BROWNS FERRY NUCLEAR PLANT (BFN) - UNITS 1, 2, AND 3 LICENSE RENEWAL APPLICATION (LRA) - RESPONSE TO NRC REQUEST FOR ADDITIONAL INFORMATION (RAI) CONCERNING FOLLOW-UP TO RAIs 4.7.7-1 AND 4.7.7-2 (TAC NOS. MC1704, MC1705, AND MC1706)

RESPONSE TO NRC REQUEST FOR ADDITIONAL INFORMATION (RAI)
CONCERNING FOLLOW-UP TO RAIs 4.7.7-1 AND 4.7.7-2

Figure 2: Relationship of microstructural related radiation induced processes as a function of flux and temperature (from Scott, Reference 3). Note: 10^{-8} dpa/s is equivalent to $\sim 1 \times 10^{13}$ n/cm²/s.

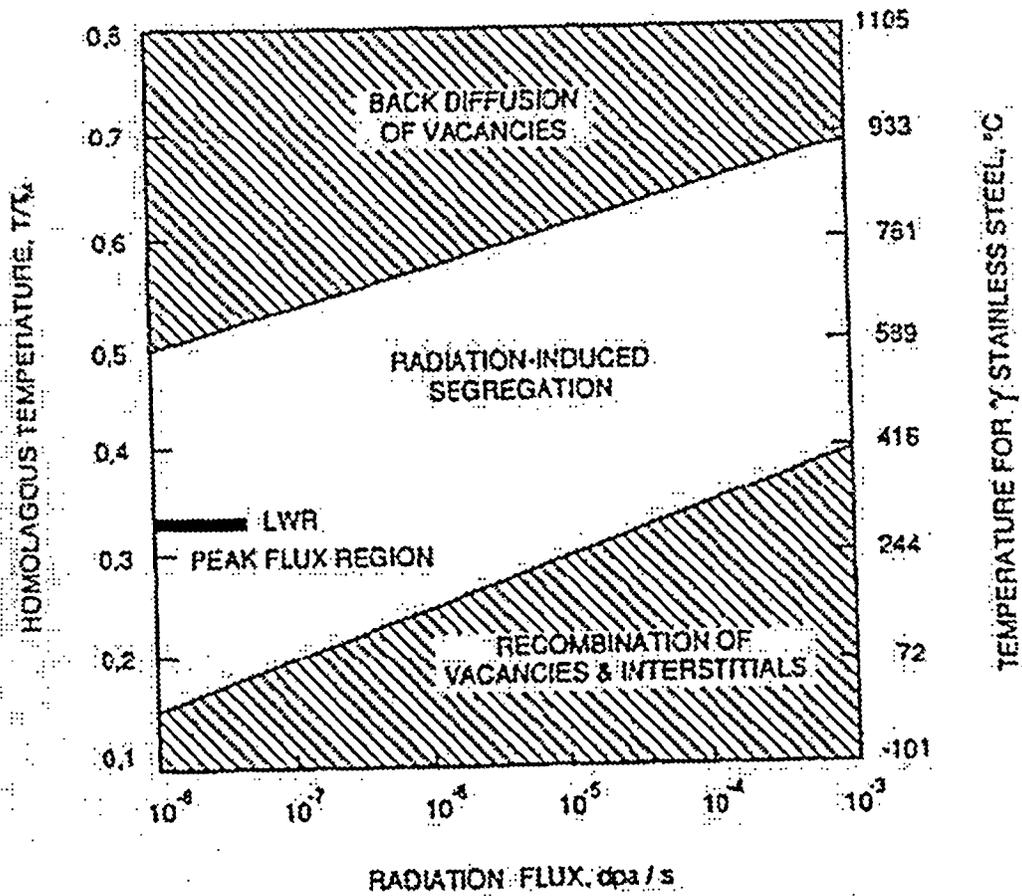
Figure 1 of the applicant's submittal dated June 29, 2005, compares the stress relaxation for the BFN core plate hold-down bolts, to the stress relaxation from the data derived from springs and bent beam stainless steel specimens. The staff request that the applicant provide information regarding the values of neutron flux and temperature at which the bent beam and spring test specimens were exposed, and compare them to the neutron flux and temperature values of the BFN's core plate hold-down bolts. If the neutron flux and temperature values for the BFN core plate hold-down bolts are different than that for the bent beam and spring test specimen data, evaluate the impact of these differences on the predicted stress relaxation values of the BFN core plate hold-down bolts.

Impact of the Temperature and Flux Differences on the Core Plate Bolts: As stated above, the temperature data were very representative of the BFN core plate bolts. The neutron flux data, however, were measured in specimens subjected to fluxes ranging from $\sim 1 \times 10^{13}$ to 2×10^{17} n/cm²/s. This is higher than the 2×10^{10} n/cm²/s average flux experienced by the BFN core plate bolts themselves. Given the large range of higher flux for which the properties are the same, the impact of the lower flux to which the bolts are exposed is viewed to be negligible. This is supported in greater detail in the following section.

relaxation and lead to very narrow changes in the local composition at grain boundaries (Reference 2). The actual evolution of the microstructure is a complex process. Additionally, the data on materials under Light Water Reactor (LWR) conditions {i.e., temperature less than 350°C (662°F), fluences in the 0.5 to 5 dpa ($\sim 6 \times 10^{19}$ to $\sim 6.6 \times 10^{20}$ n/cm²) and attributable to a LWR neutron spectrum} is limited (Reference 3). Below this fluence level, degradation is just starting to occur. Following a short-term transient, the creep strain at constant load is very linear with fluence (which in turn is integrated flux over time) (Reference 4). Scott showed that the LWR operating flux/temperature region is one broadly associated with processes of limited microstructural dimension that in turn is associated with radiation-induced segregation (RIS) (Figure 2) (Reference 3). The continuity of these processes to lower flux levels is very much implied by Figure 2 for LWR material changes. Therefore, extrapolation of the higher flux data to the core plate region is fully justified and appropriate. Consistent with other microstructural processes, higher temperature and higher fluxes would be expected to produce bigger changes. The lower flux conditions would produce no additional effect on the relaxation behavior.
